# Quality Control Report

**Consultant** **Wahib Medanat** Consultant Engineers  
**Site Name** **Al Khansa'a Basic Mixed - Balqa**  
**Package** **Package 1**  
**Contractor** **Derar Saraireh & Sons for Engineering & Contracting**  
**Tender No.** **1/2020/USAID/SKEP/3/1**

**Rep No.** **QC-12 11**  
**Date** **12 / 01 / 2022**

**Broken sill and shortage in length**

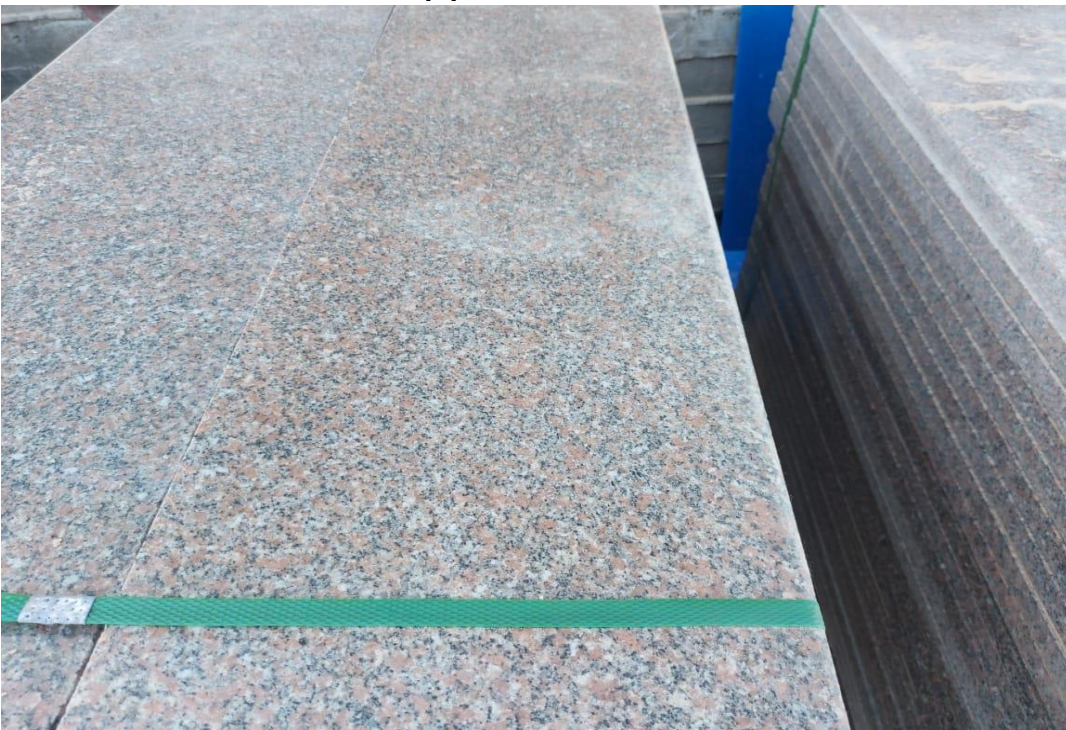
Description of Non-Conformance	Corrective Action	Required by / When
1. Damaged cartonal boards and asphalt paint for the external concrete footing members. 2. Wall tiles: Cut-off pieces at the sides are less than the minimum required. 3. Broken window sills and length is less than required.	1. To be replaced with new boards after re-painting by asphalt. 2. To be removed and re-tiled as per requirement. 3. To be replaced.	The Contractor/Immediately
<b>Report Prepared by</b>	Hassan Shaqbua, Supervision Quality Control Manager	
<b>Contractor's Response</b>		
The Contractor rectified the defects in stone around the rain water outlets and created the required grooves in the treads of the staircase at the factory.		
<b>Notes</b>
